DATE: August 3, 2018
FROM: REI Engineers
TO: Bidders of Record
REFERENCE: **Addendum No. 01**
Henderson County, North Carolina
Main Library Roof Replacement
REI Project No. 018CLT-069

This addendum consists of 1 page, Pre-bid Meeting Minutes, the attached revised Specification Sections 00 01 15 List of Drawings; 00 41 13 Bid Form; 07 54 00 Thermoplastic Single Ply Roofing and the attached revised Drawings XR-101 and XR-202.

SHEET NO:
XR-101

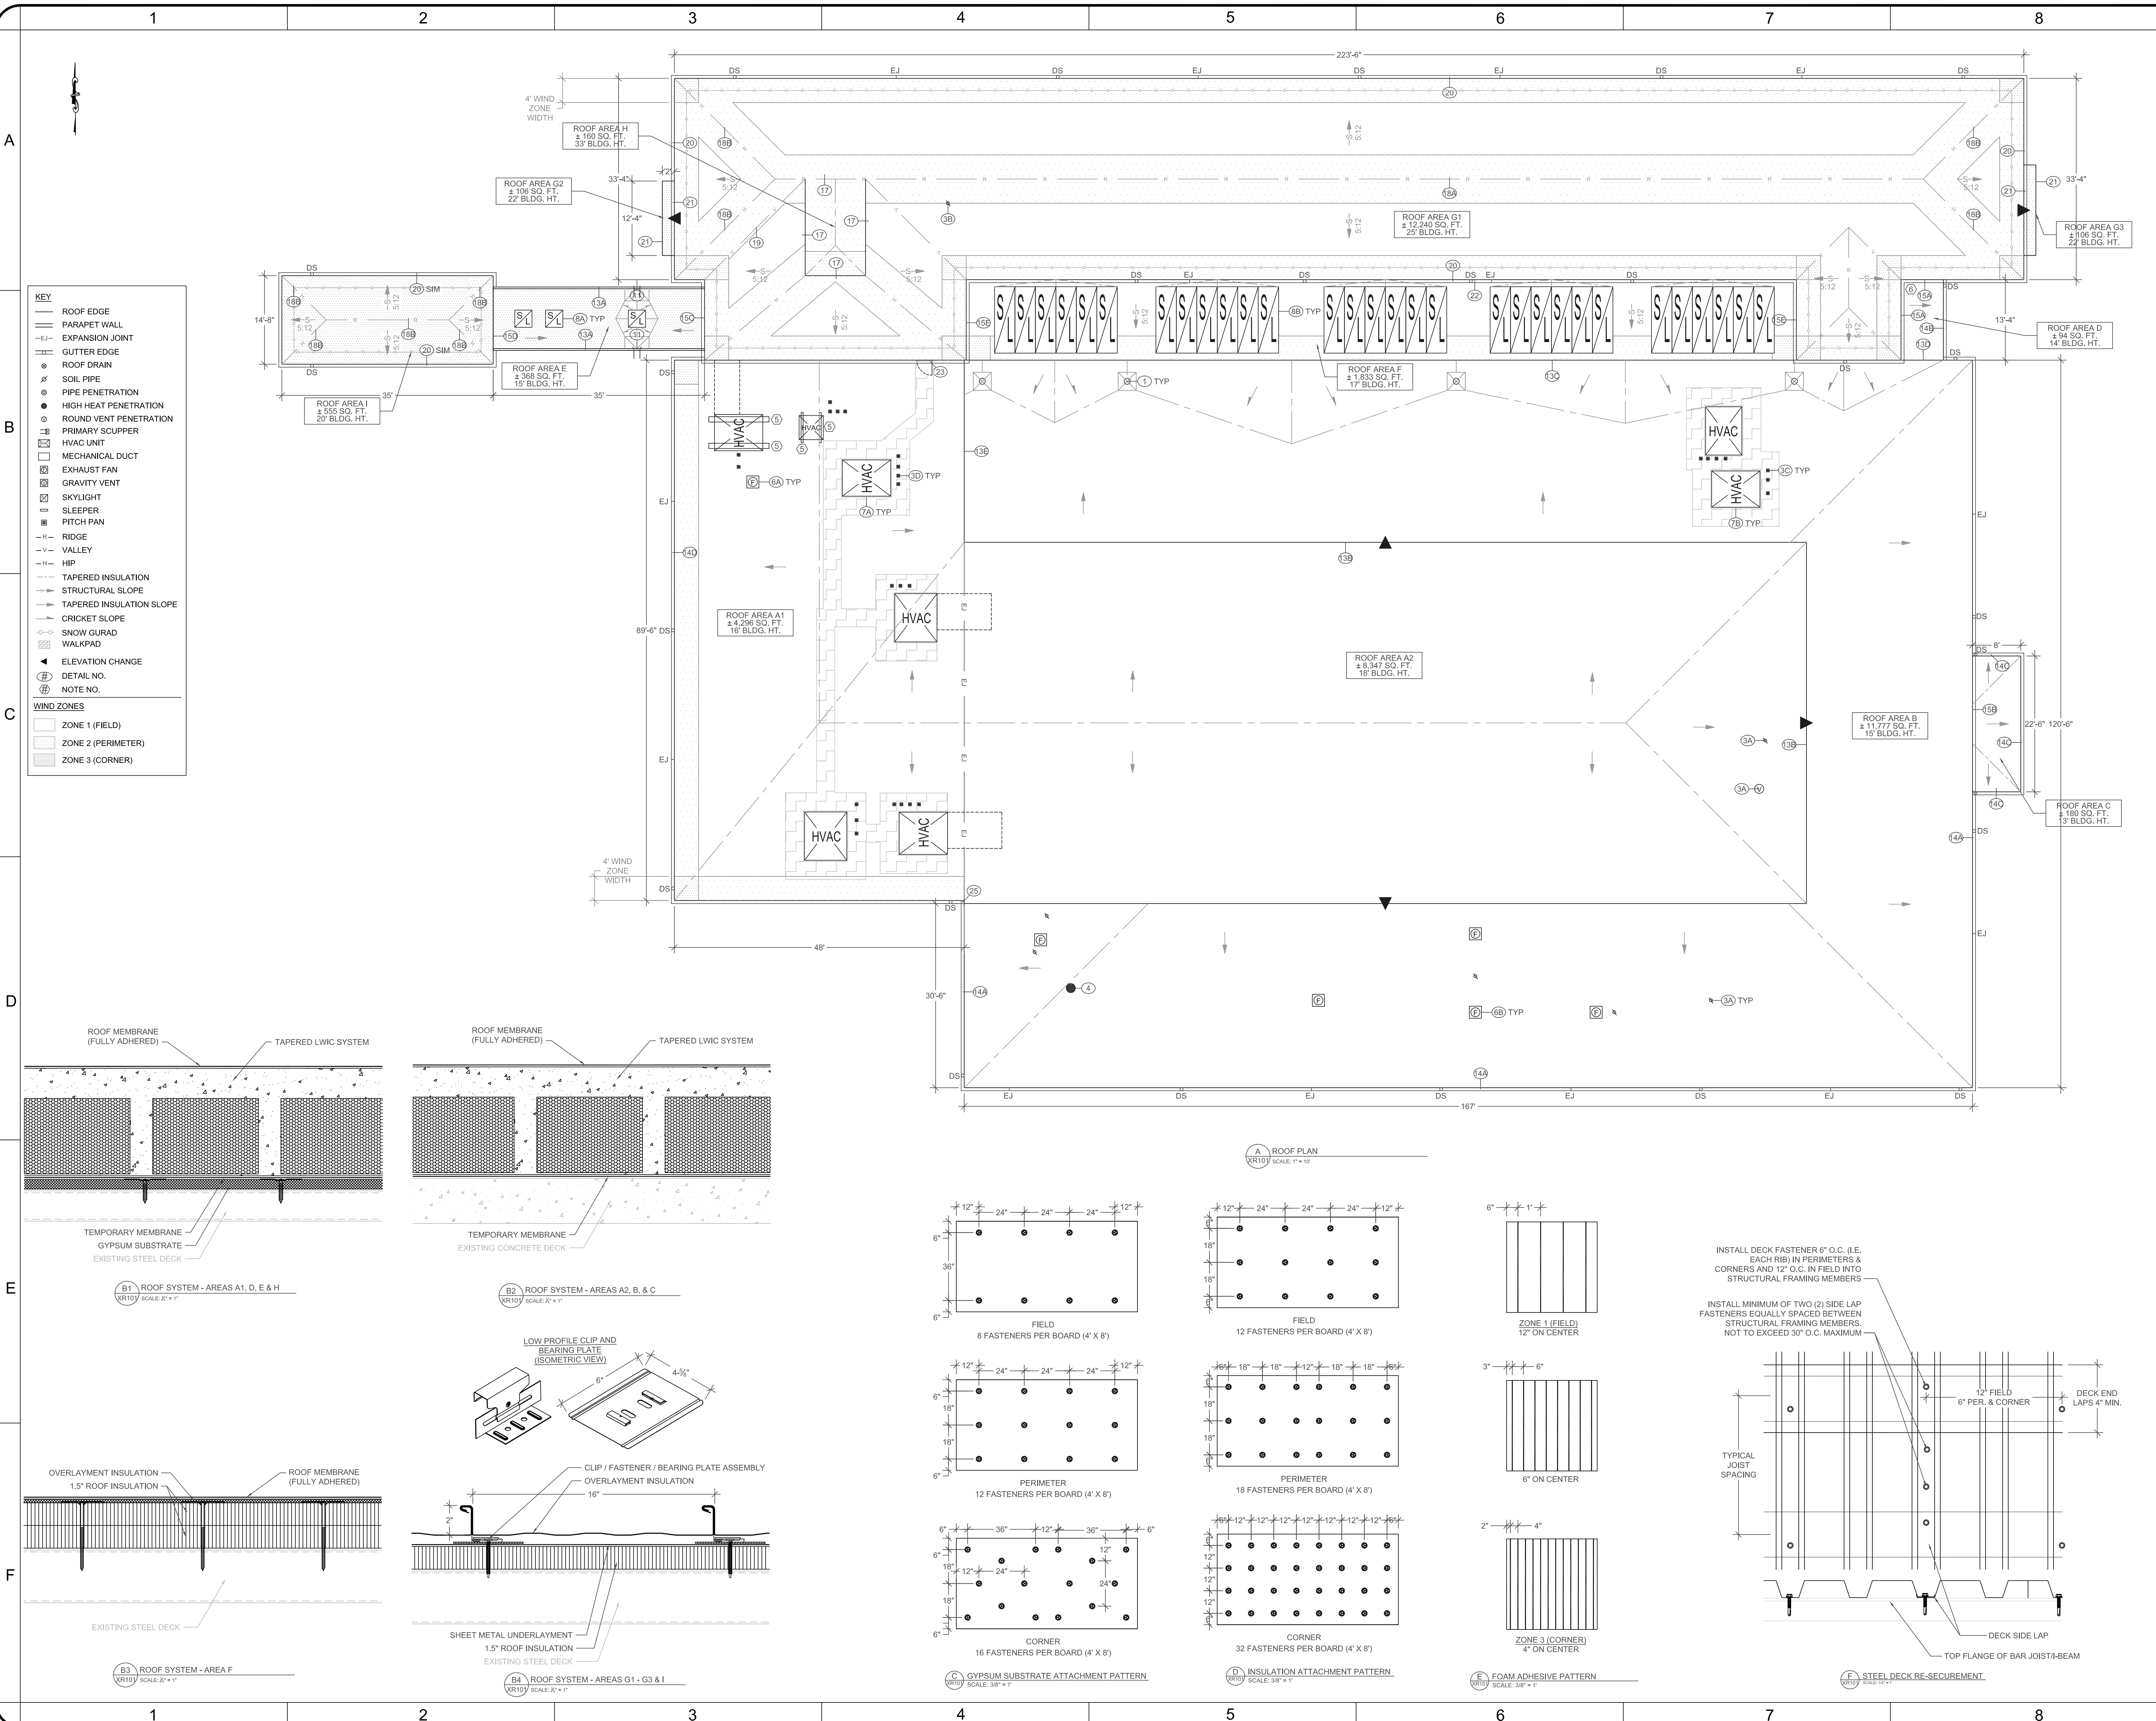
5. Revised sheet XR-101; Detail numbers 21 and 22 have been moved to their correct locations.
6. Revised sheet XR-202; Detail 8A has been revised to indicate replacement of the skylight domes on Area E with matching domes to be included in the base bid.

REVISIONS:		
NO.	DATE	DESCRIPTION
01	07/30/2018	CORRECTION OF DETAIL CALLOUT #21 & #22

21. On the roof plan XR-101, Details 21 and 22 are transposed from each other. The North side of roof Area F is Detail 22; Roof Areas G2 and G3 are Detail 21.
22. Roof Area E, Detail 8A the existing skylights shall be removed and replaced with a new skylight matching the original.

XR-202

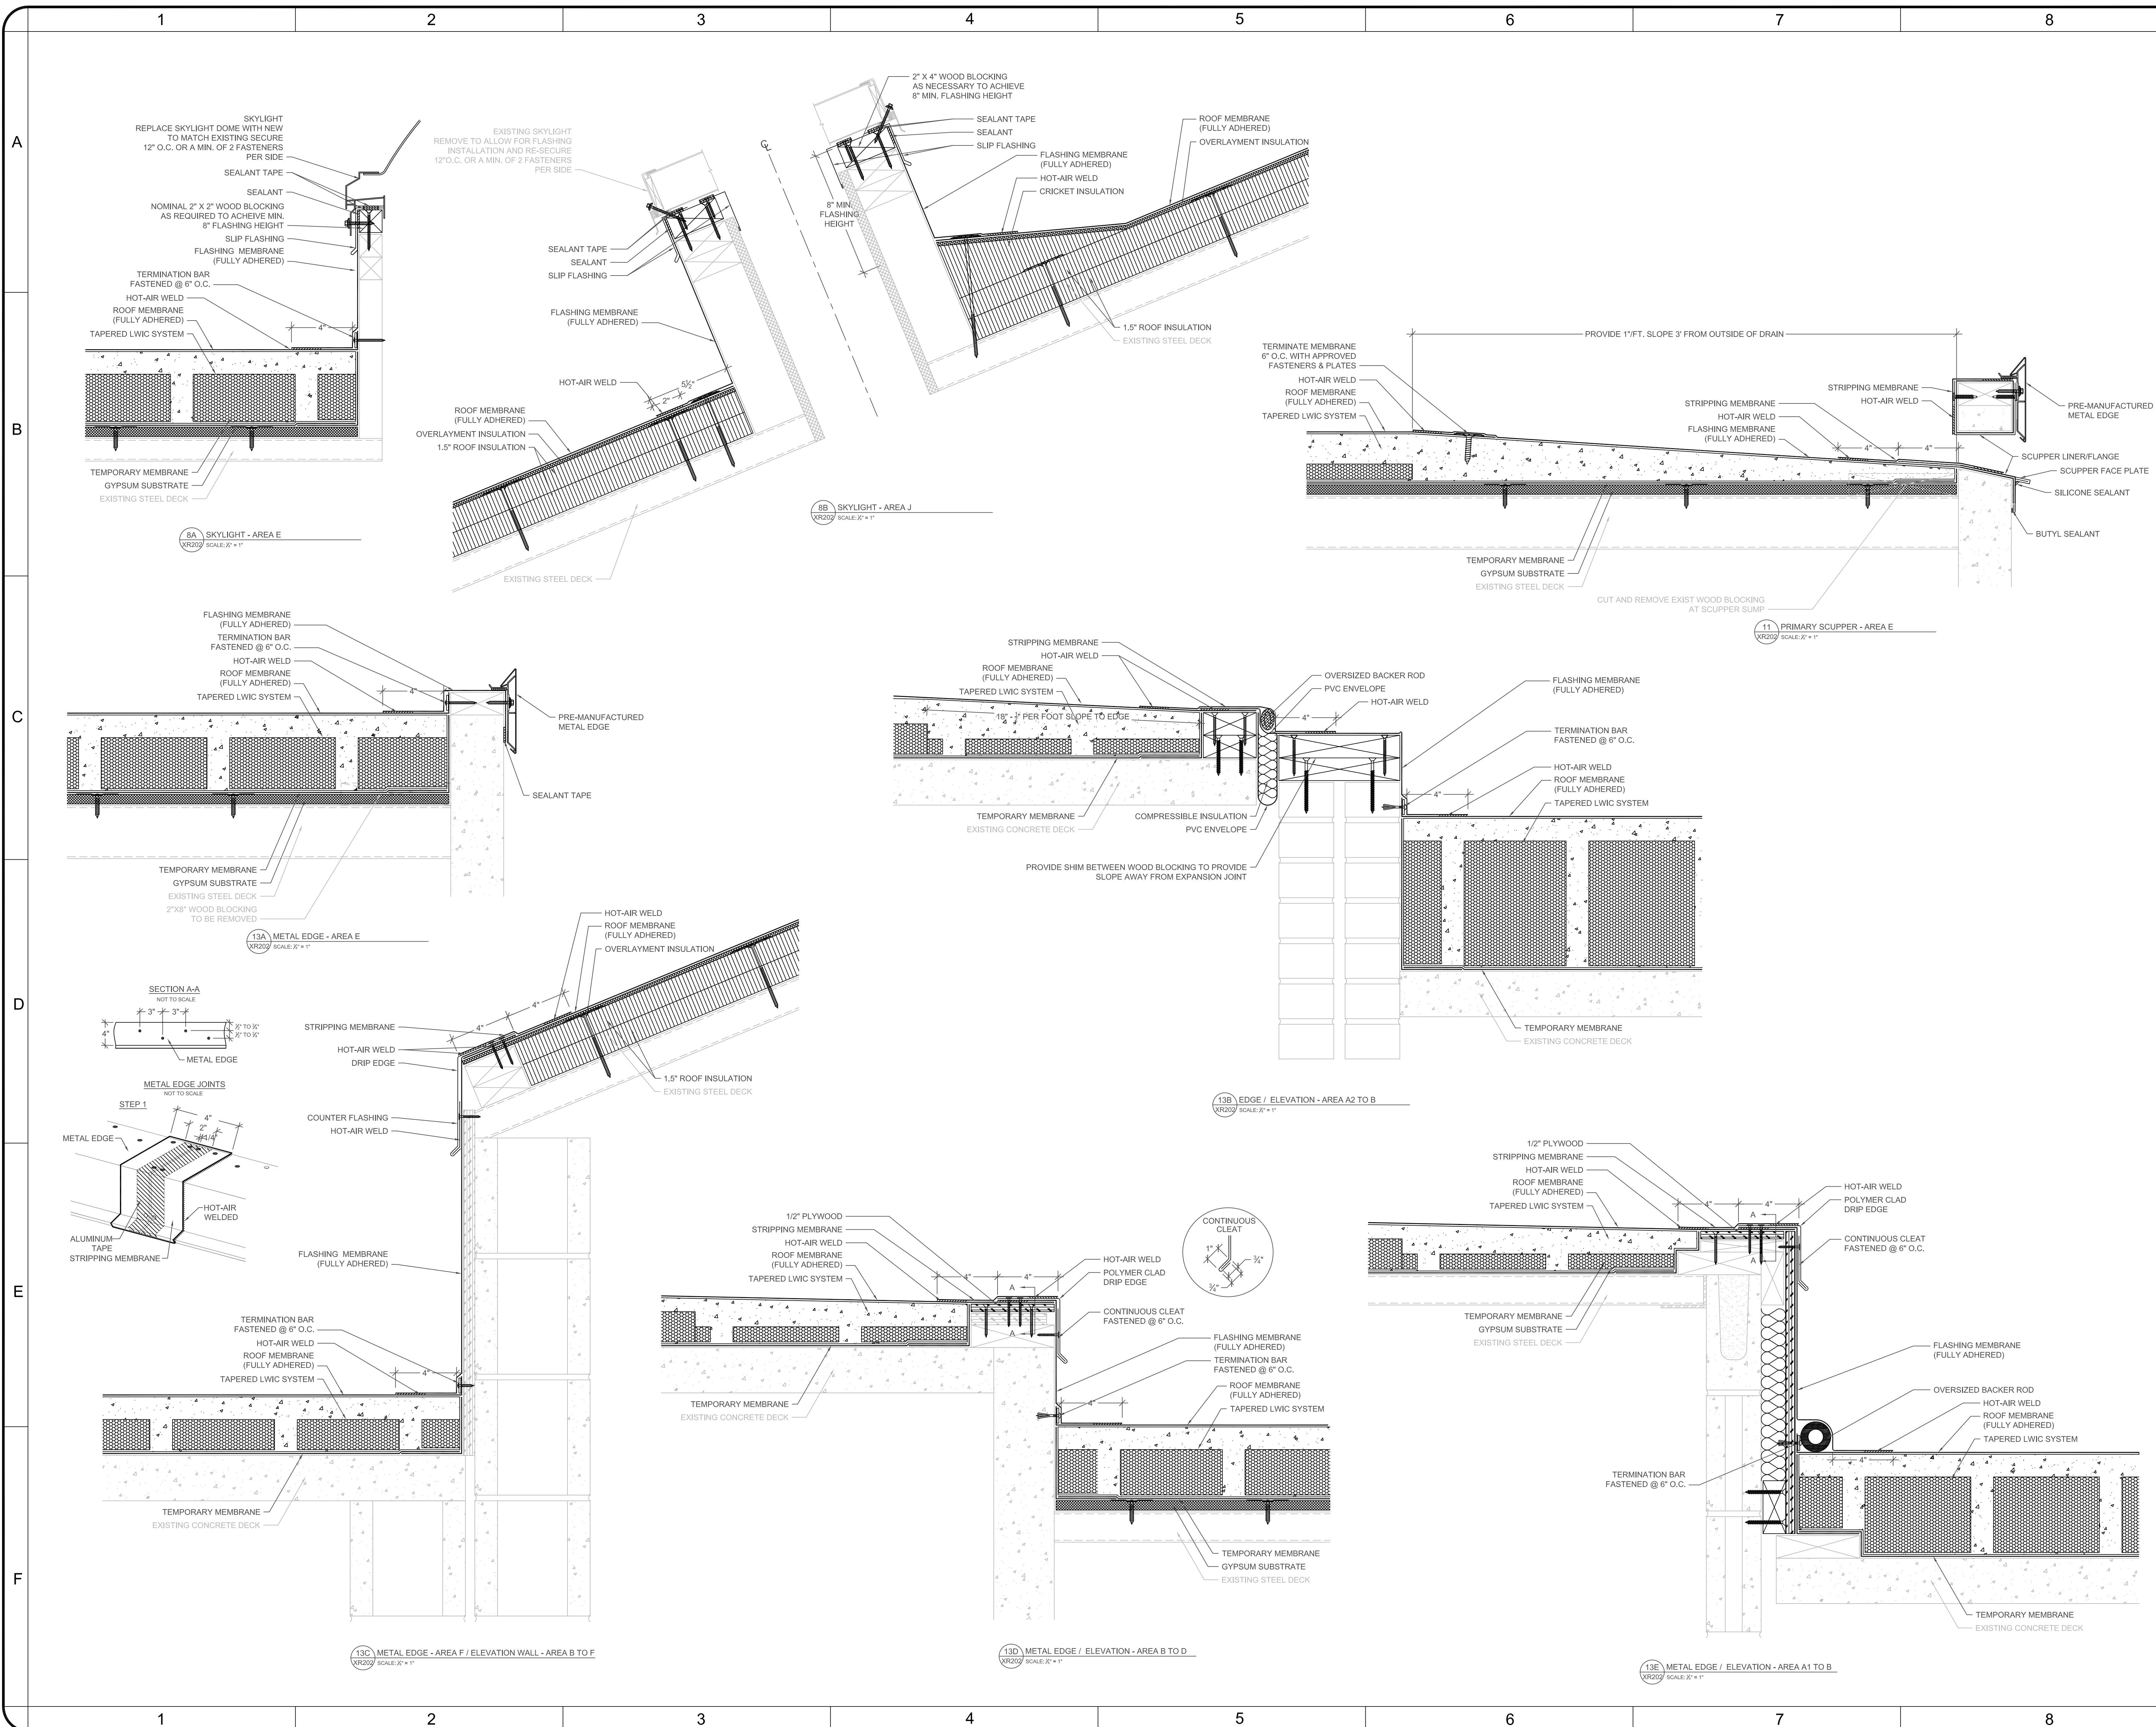
NO.	DATE	DESCRIPTION
01	07/30/2018	CHANGE TO DETAIL 8A CALLOUT #21 & #22
